ORIGINATION FORM

Proposed Revisions to a Standard Plans Index
(Please provide all information — Incomplete forms will be returned)

Index Number: 649-020
Sheet Number (s): All Sheets
Index Title: Steel CCTV Pole

STEEL CCTV POLE ASSEMBLY

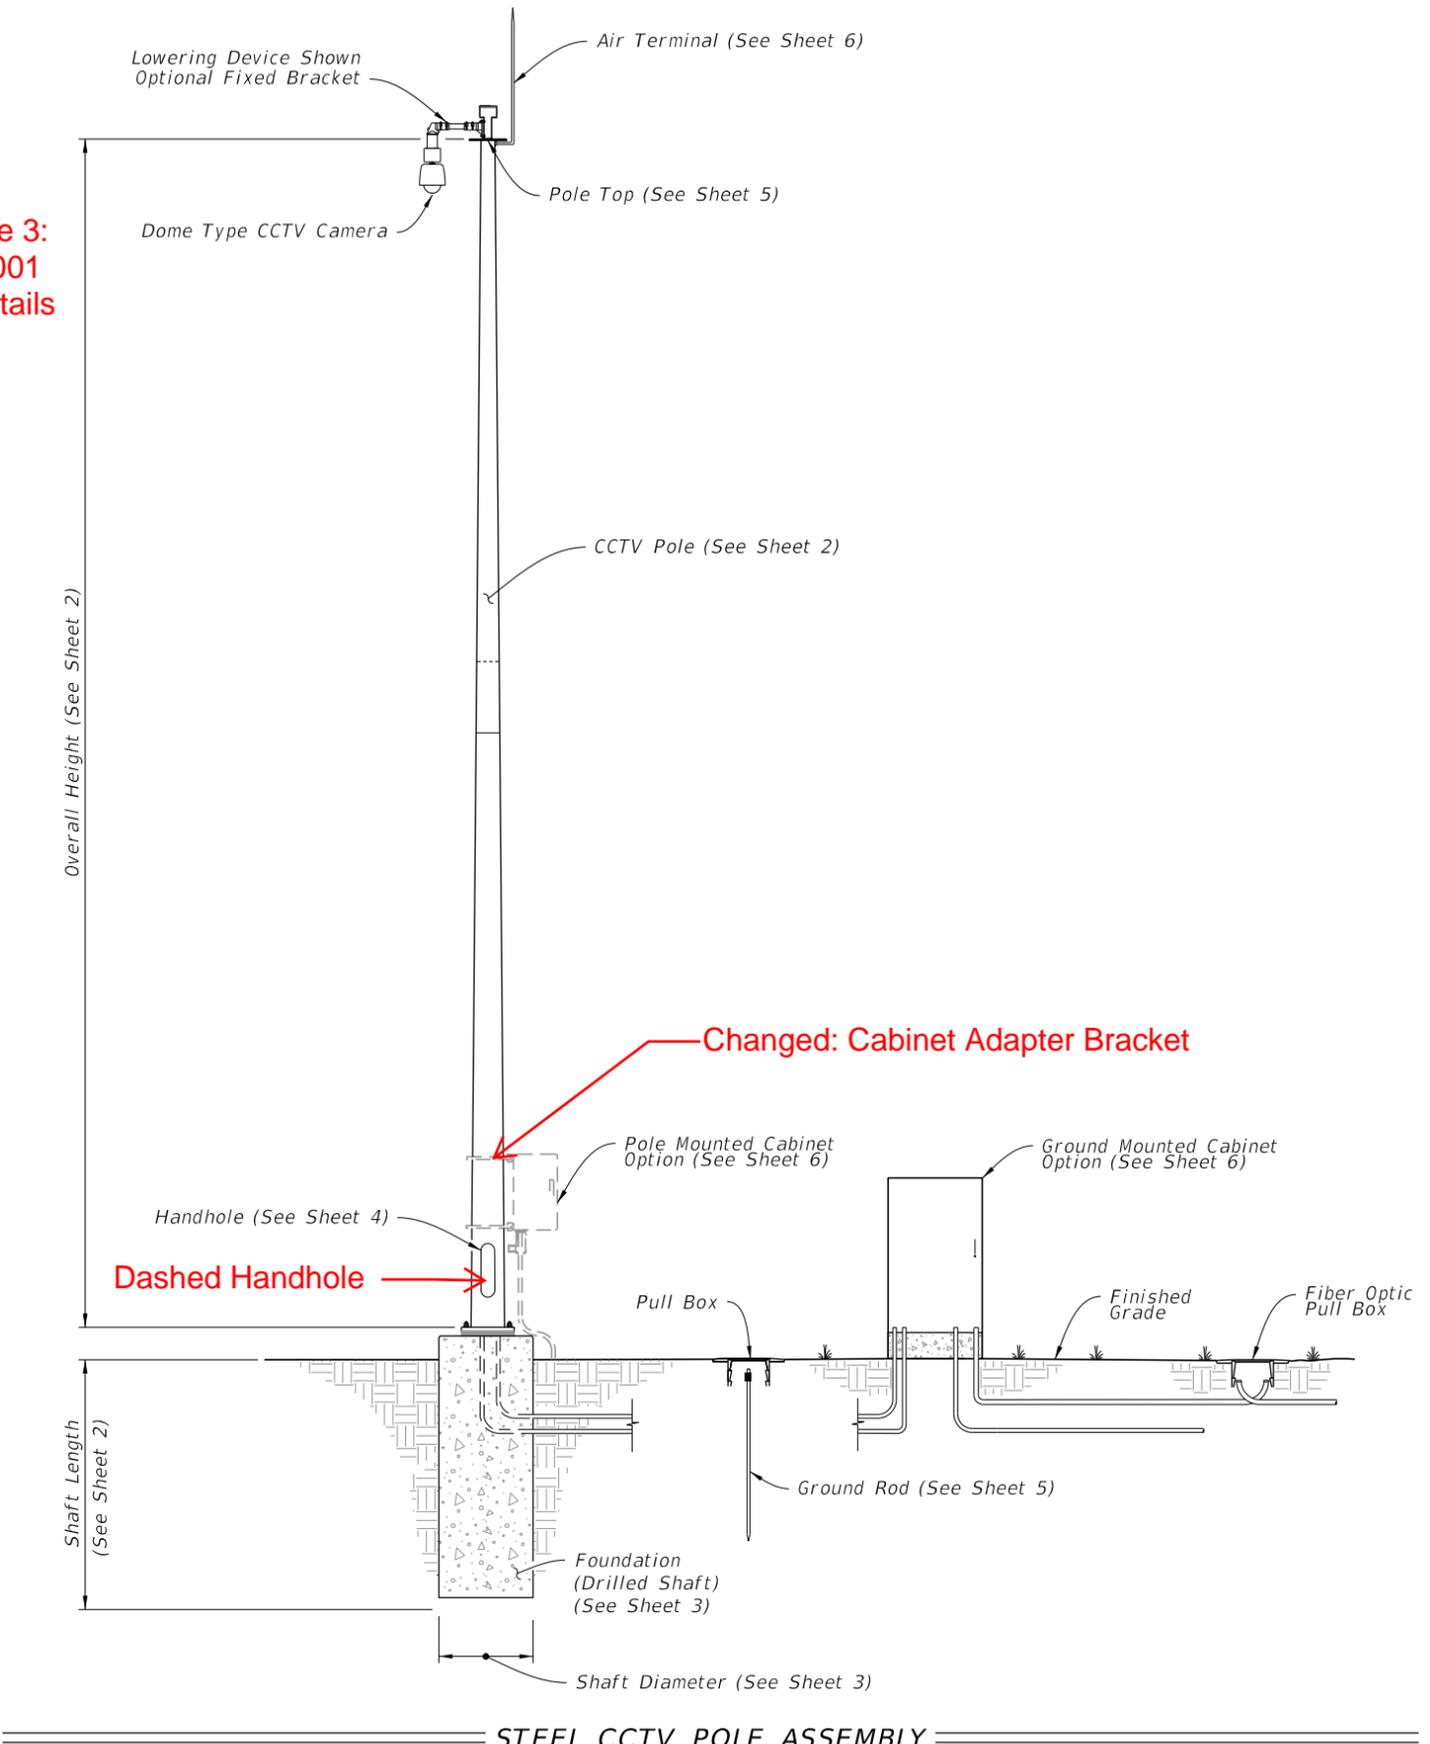
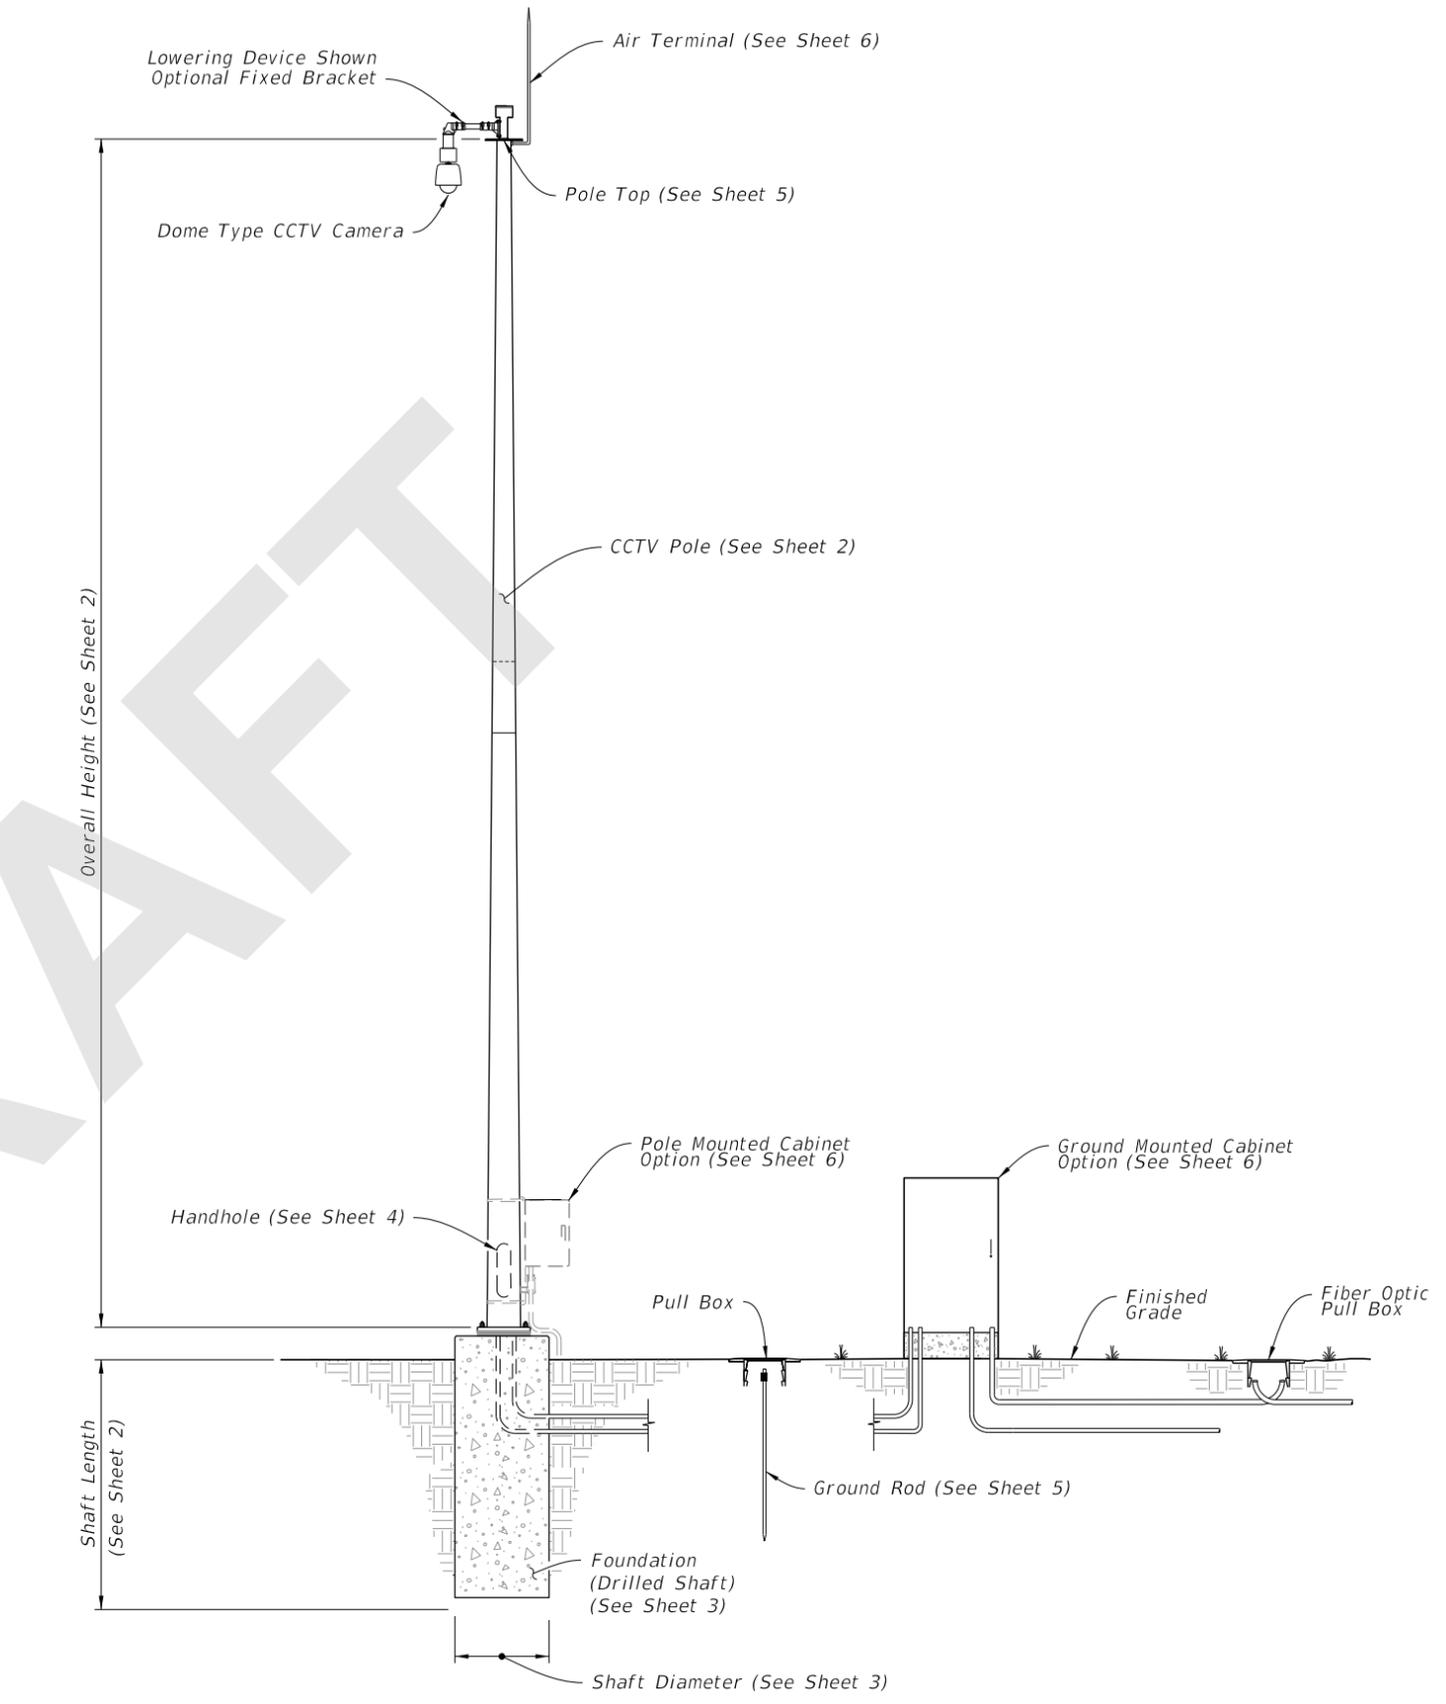
- Sheet 1: Added Note 3 to the General Notes to stay consistent with 641-020; Added Note D and E to new Note 6; Added the Cabinet Adapter Bracket and dashed the handhole in the STEEL CCTV POLE ASSEMBLY detail.
- Sheet 2: Updated the Assembly detail to match Sheet 1; Dashed the handhole in the ELEVATION detail.
- Sheet 3: Updated the Assembly detail to match Sheet 1.
- Sheet 4: Updated the Assembly detail to match Sheet 1. Update Note to "See Note" on Cover Plate Detail.
- Sheet 5: Updated the Assembly detail to match Sheet 1.
- Sheet 6: Dashed the handhole in the CONCRETE CCTV POLE GROUNDING detail and added the handhole to DETAIL "E"-SIDE VIEW detail.

Changed: Cabinet Adapter Bracket

Dashed Handhole

Added New Note 3:
See Index 635-001
for additional details
for Pull Boxes.

Added Note:
D: Install Pole with
the handhole located
away from
approaching traffic.

Added Note E:
Install the Pole
plumb.

ELEVATION

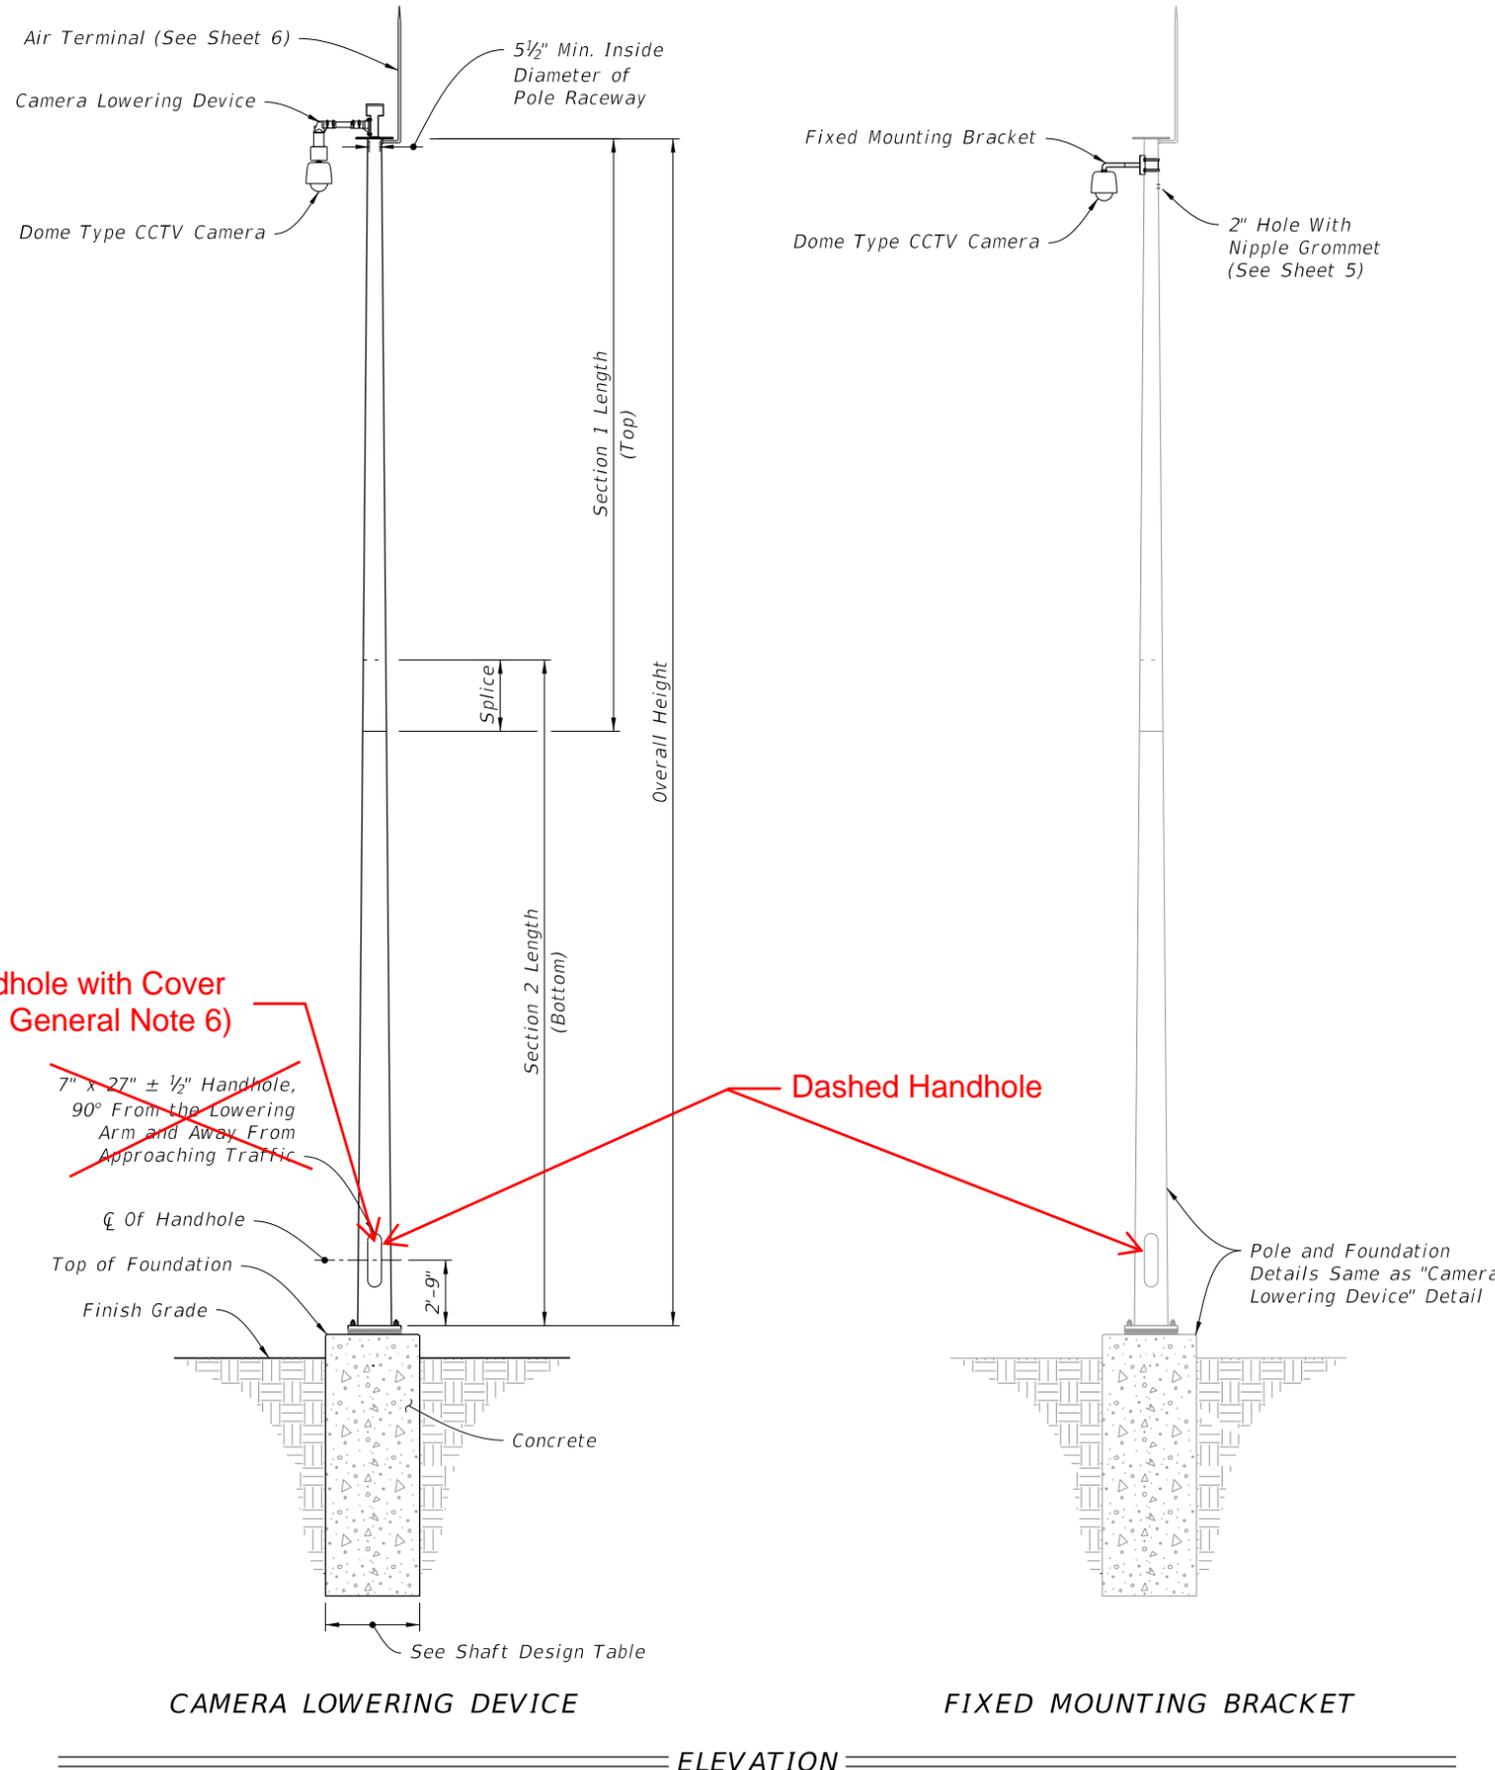
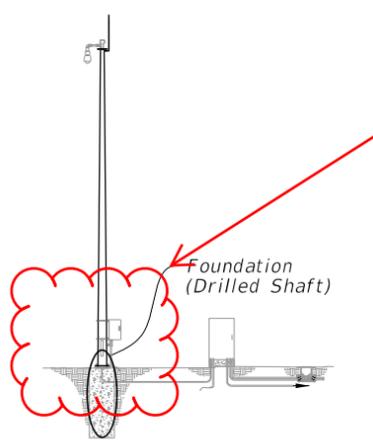
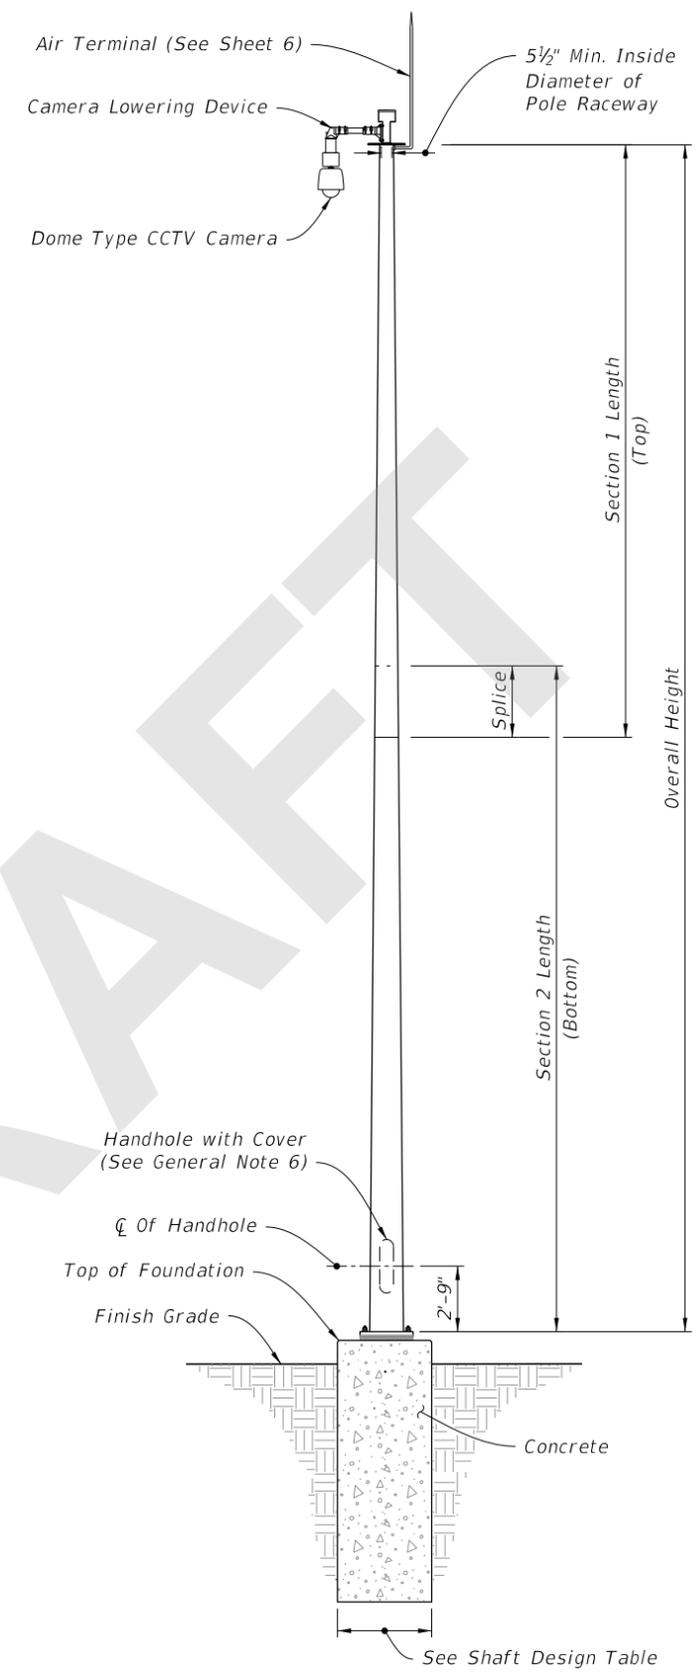
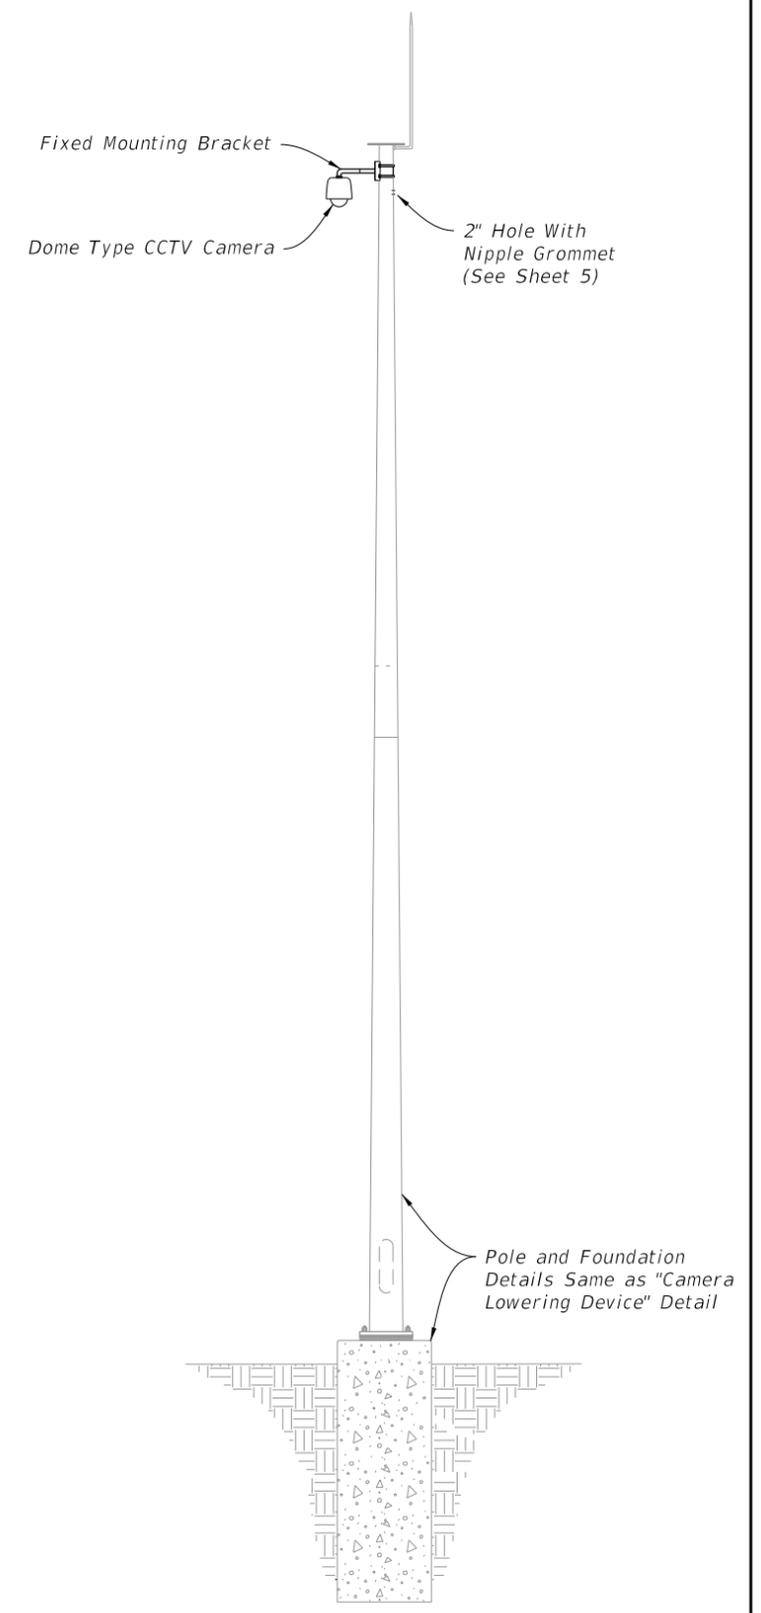
Updated Detail to match Sheet 1

Handhole with Cover (See General Note 6)

Dashed Handhole
